**Re: Site Plan – Upper Slate School
5100 Ridge Road
North Haven, Connecticut
SLR #141.16156.00003**

SLR International Corporation (SLR) is in receipt of your memorandum dated April 14, 2021, regarding the above-referenced project. We offer the following responses to the comments contained therein:

SK-1

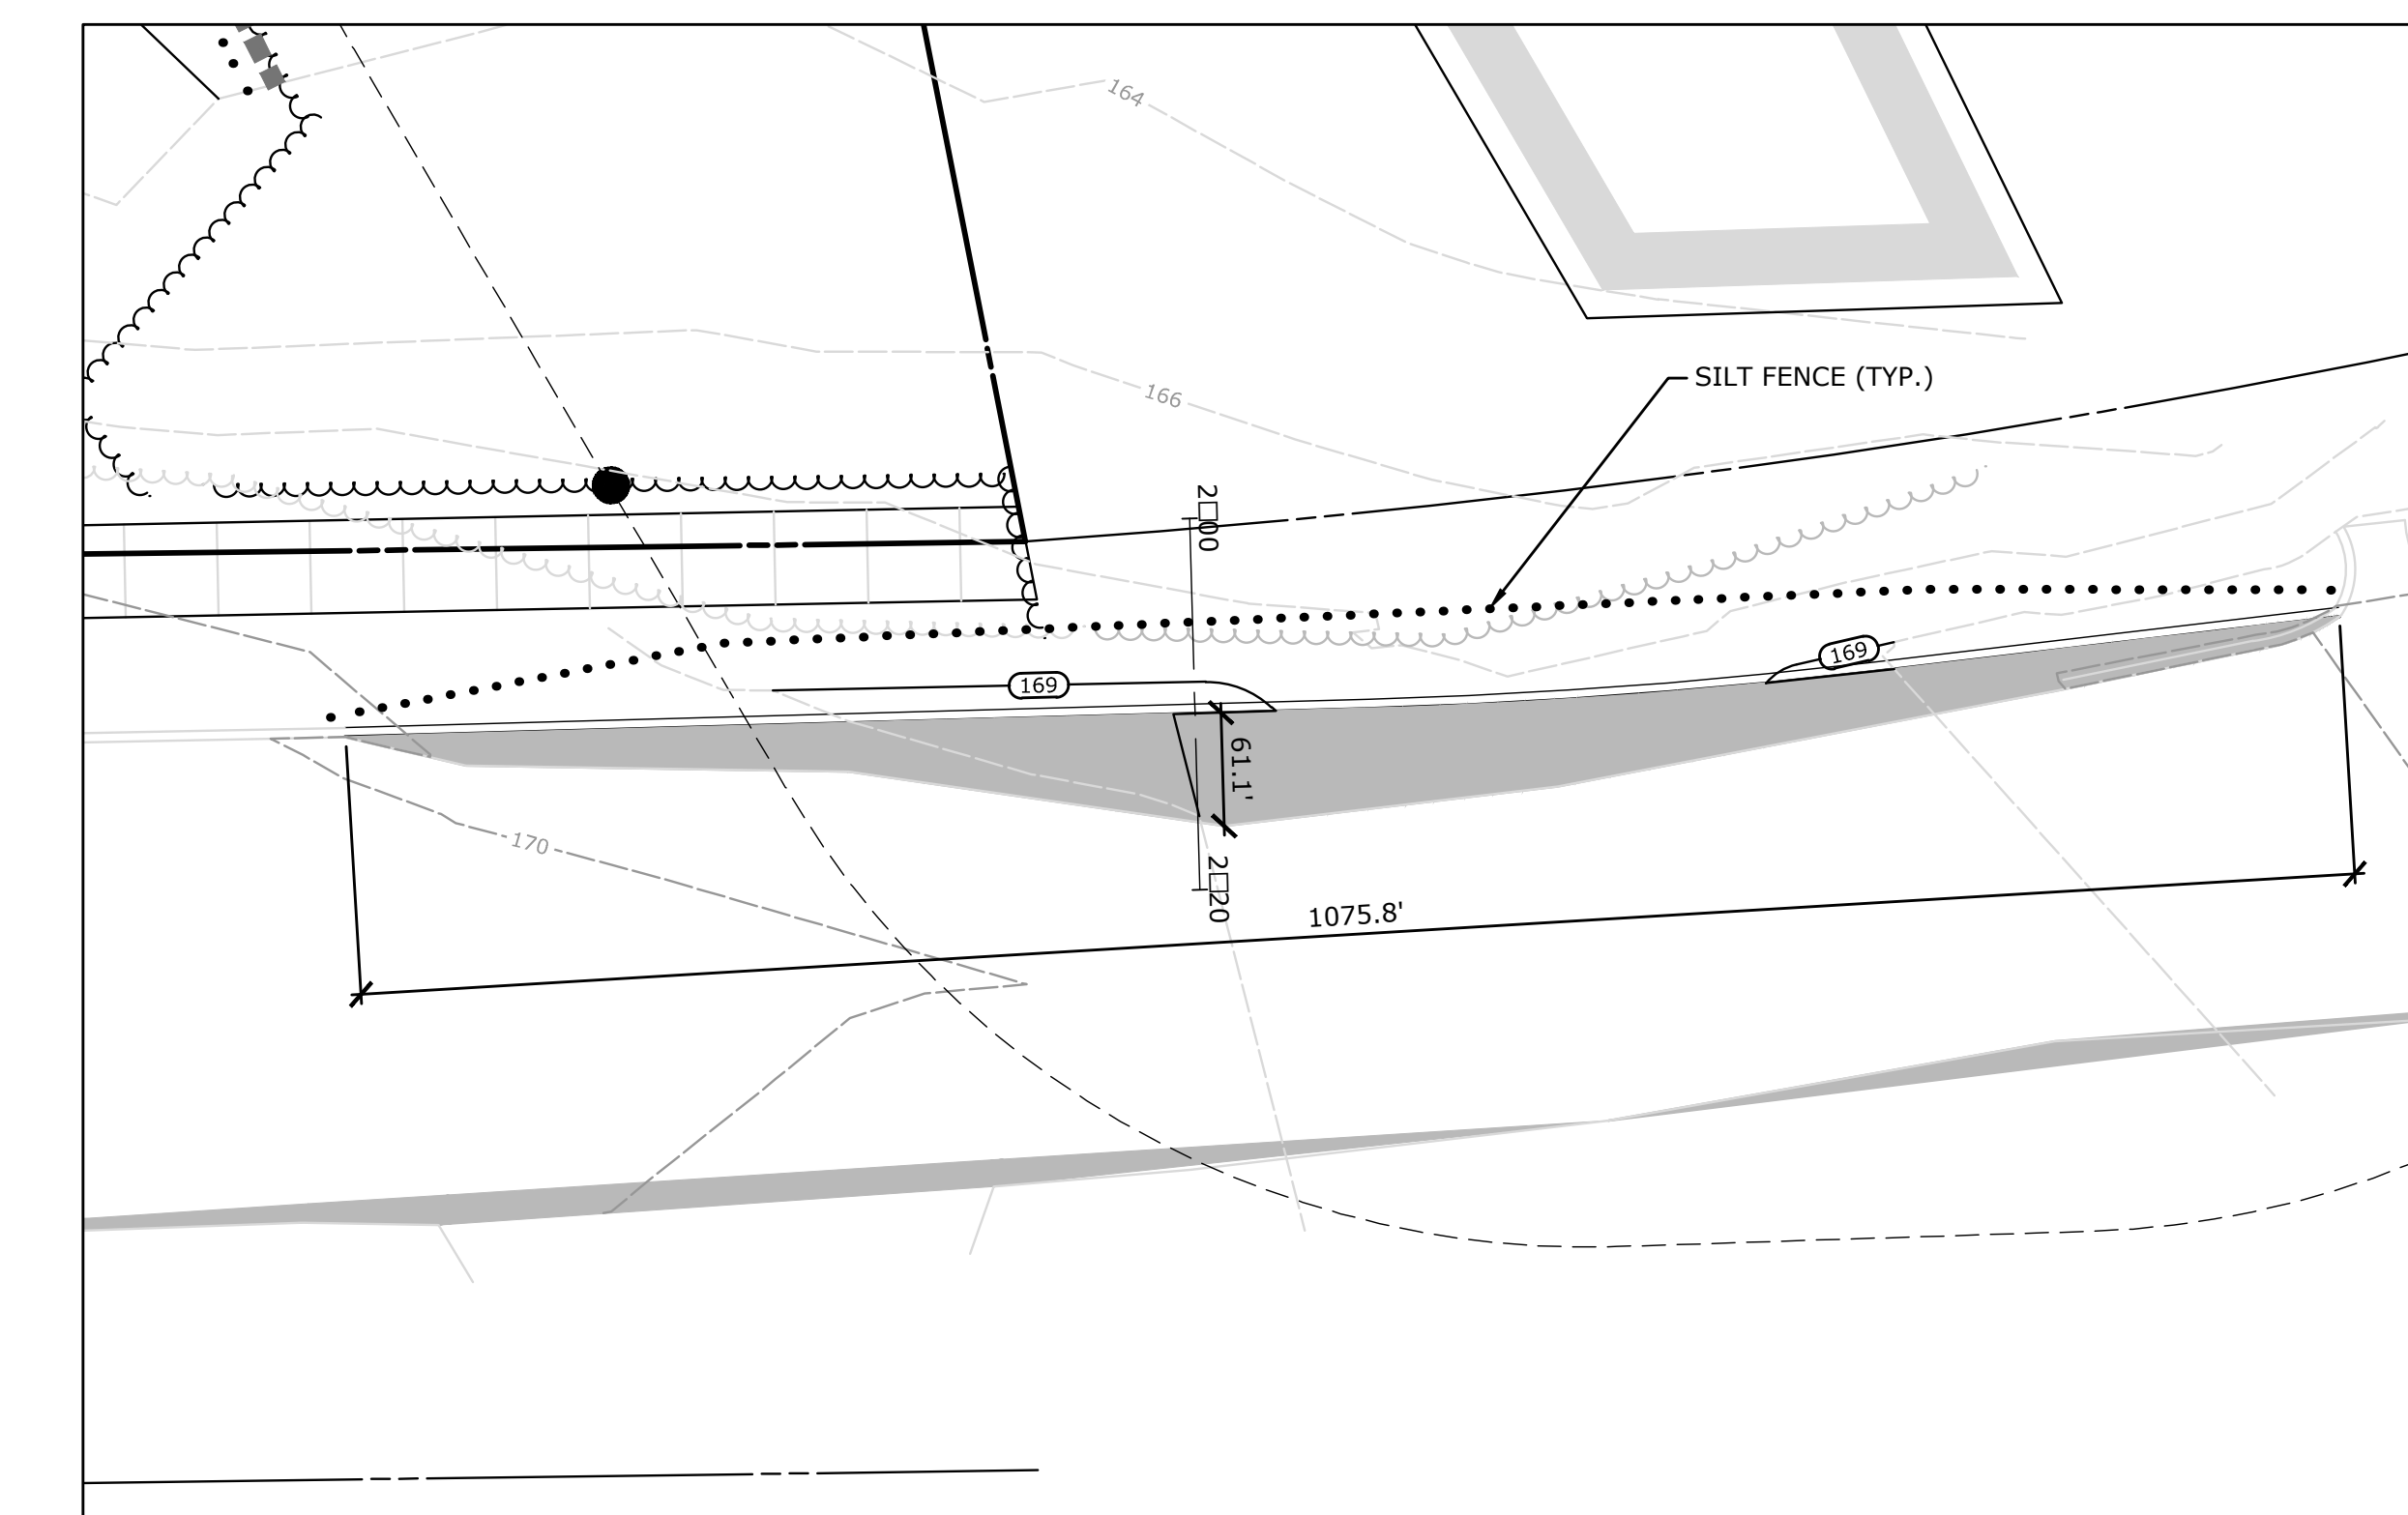
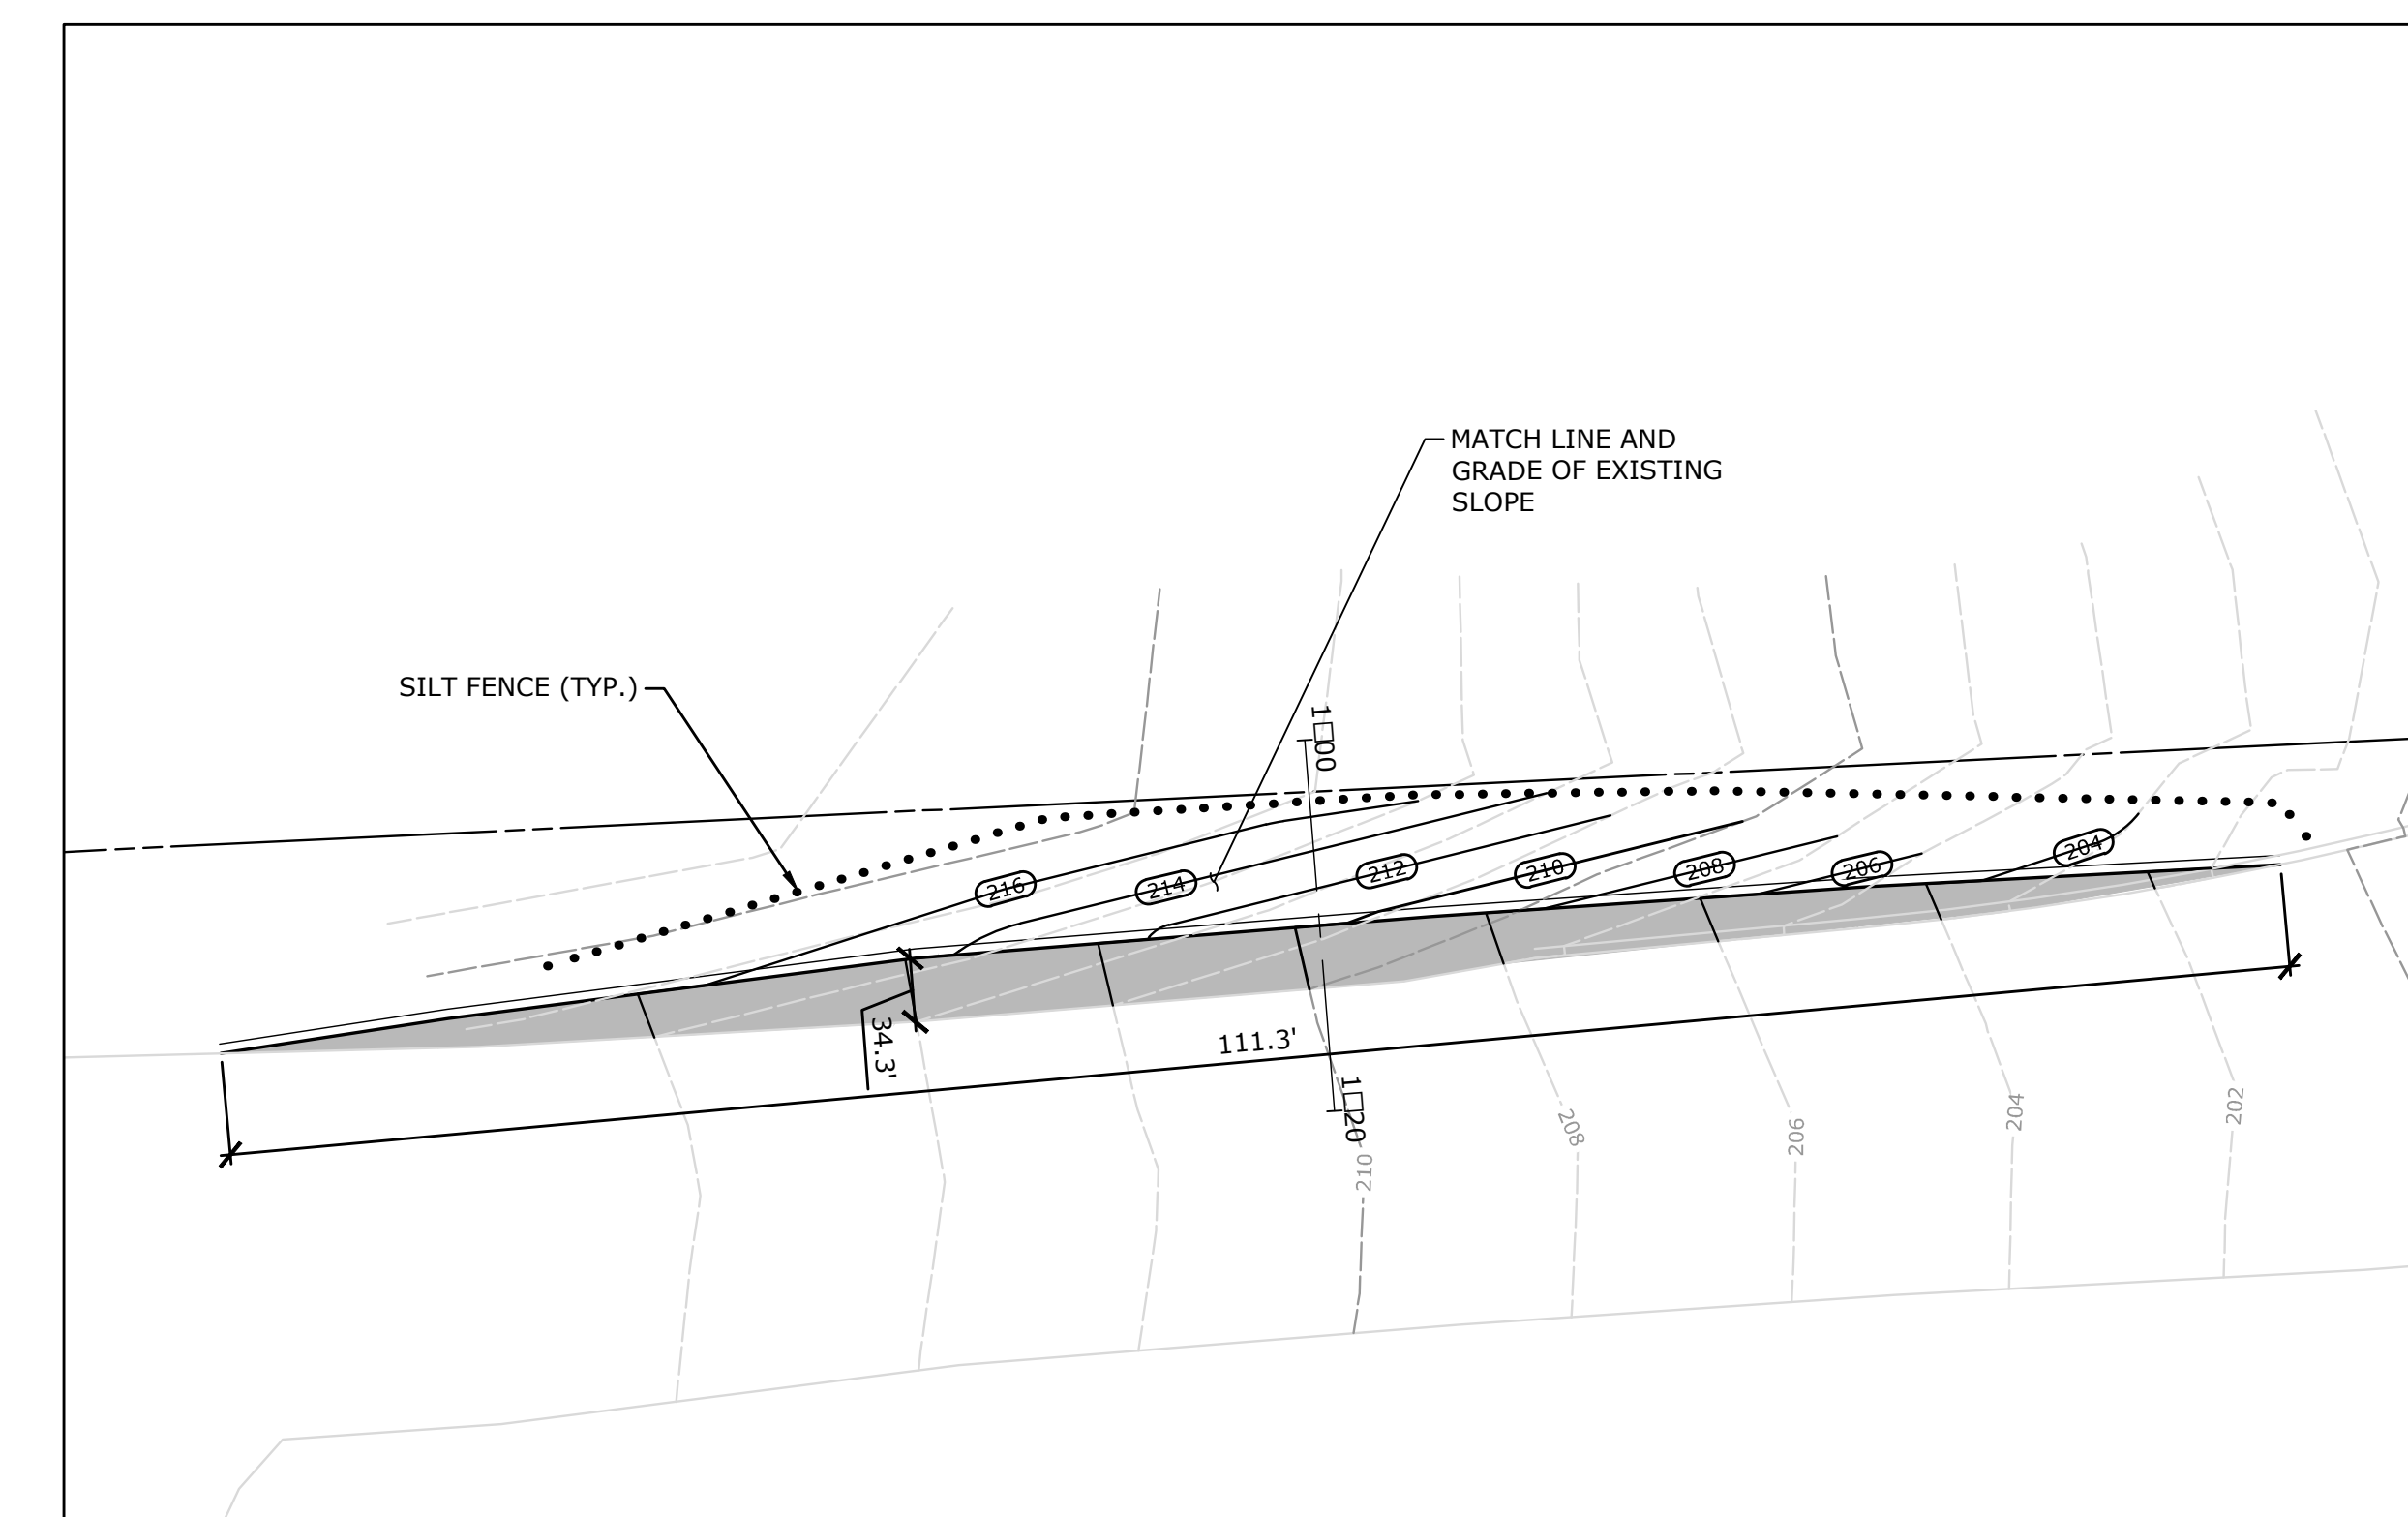
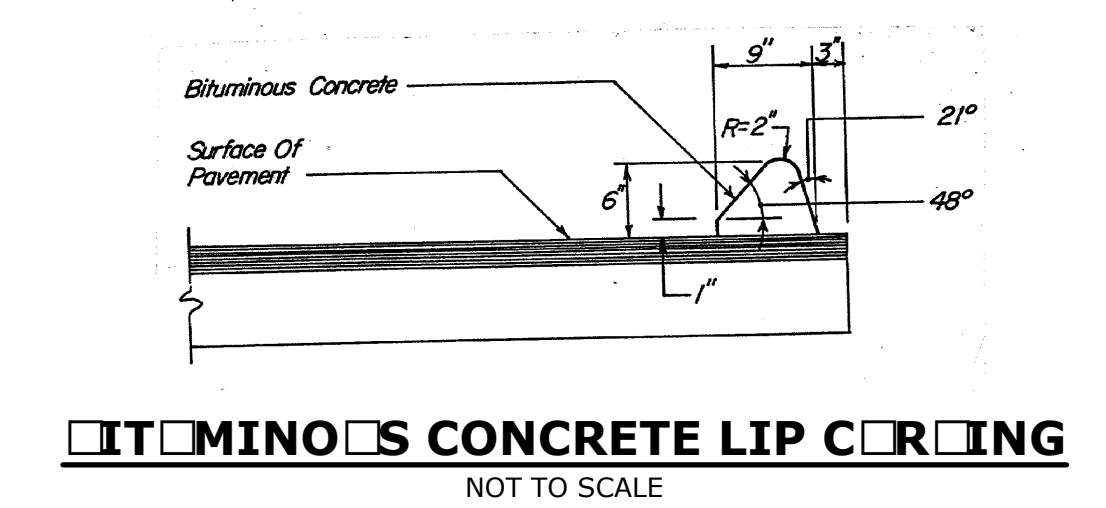
- R1. Noted.**
- C2. More detail is needed on the proposed road widening including cross sections, detailed grading plans, a detailed layout plan (with dimensions), and details on the proposed pavement section, and bituminous curb. A line of silt fence should be provided downgradient of the road widening section. Coordinate relocation of the existing utility pole within the southerly road widening area.

- R2. Please see enclosed sheet SK-1.**
- C3. MH 17 should be replaced with a Gross Particle Separator in order to screen stormwater prior to entering the underground detention system.
